Planning App Ref:	PL/2025/09484
Service Ref:	Drainage
Date:	03/07/2026

Outline planning application with all matters reserved except for access for up to 135 dwellings, the creation of new vehicular access with footways from Swindon Road, provision of informal and formal open space, together with associated highways, landscape, earth works and level changes, foul and surface water drainage facilities, utilities provision and other associated and necessary infrastructure.

Land North of Swindon Road, Royal Wootton Bassett

Figure 3: Topographical Catchments of Developable Area of Site

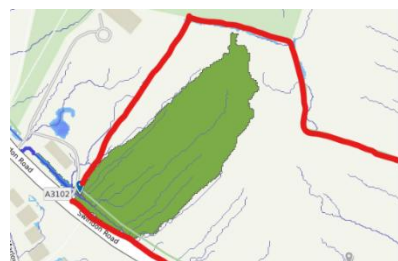
Catchment Transfer: *"Evidence to demonstrate there is no catchment transfer by discharging flows to the eastern watercourse. The applicant is required to demonstrate there is no increase to flood risk downstream as a result of the development".*

The applicant has undertaken a catchment analysis of the greenfield scenario at site. Figure 3 demonstrates that in the greenfield scenario, the eastern catchment (purple) falls and discharges to the ditch.

The western catchment (blue) drains southwards and falls towards the highway – potentially contributing to the modelled surface water flooding experience on the highway (Scalco analysis on right).

The applicant proposes to discharge surface water from the entire site to the ditch. The applicant has demonstrated there will not be catchment transfer as the attenuation provided onsite & restricted discharge rate of 7.5l/s provides betterment on the existing eastern catchment runoff towards the ditch in the greenfield scenario. Summarised calculations of this can be found in Table 2-5.
